**TOWN OF NEWBURGH
PLANNING BOARD
TECHNICAL REVIEW COMMENTS**

PROJECT NAME: AVION VENTURES-WAREHOUSE
PROJECT NO.: 24-16
PROJECT LOCATION: SECTION 86, BLOCK 1, LOT 37.222
REVIEW DATE: 26 NOVEMBER 2025
MEETING DATE: 4 DECEMBER 2025
PROJECT REPRESENTATIVE: COLLIERS ENGINEERING AND DESIGN – CONNOR MCCORMACK, PE

UTILITY PLAN

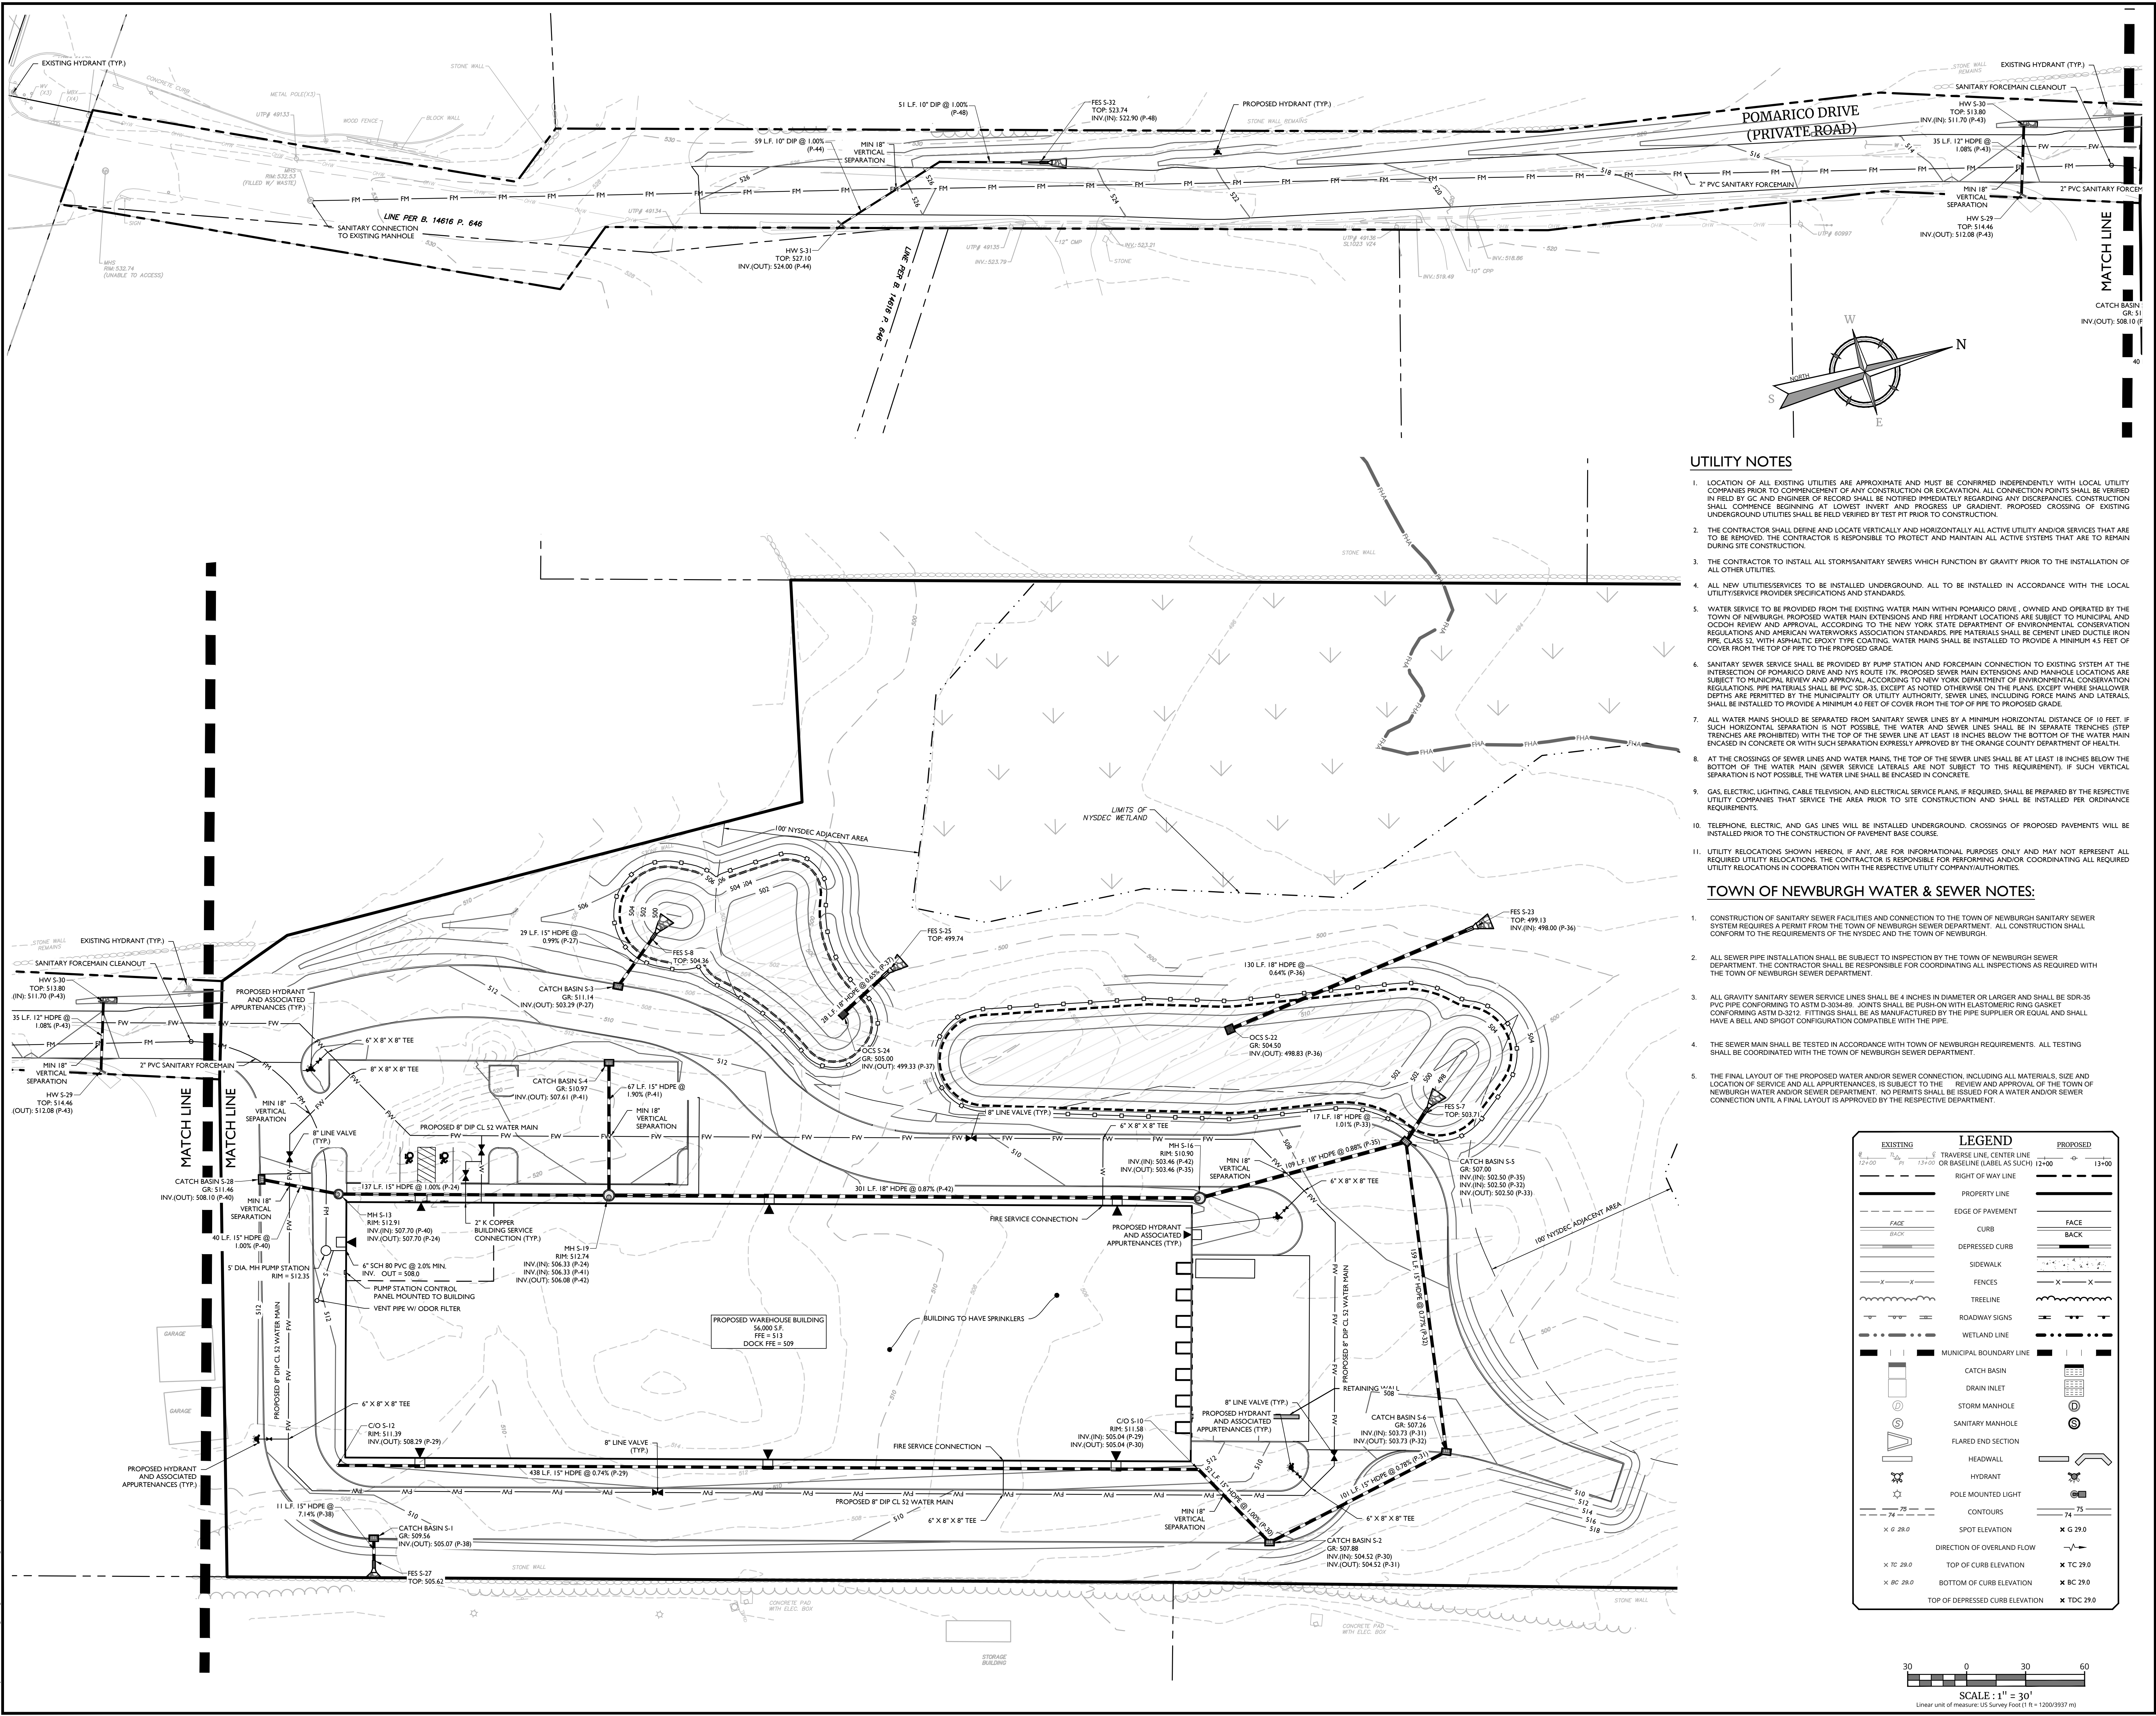
9. The force main connection to existing manhole identifies the manhole as "filled with waste". Confirmation of the inverts should be provided for the gravity sewer within Pomarico Drive. The next down gradient manhole also noted as unable to access.

10. The connection point to the Towns water system should be identified.
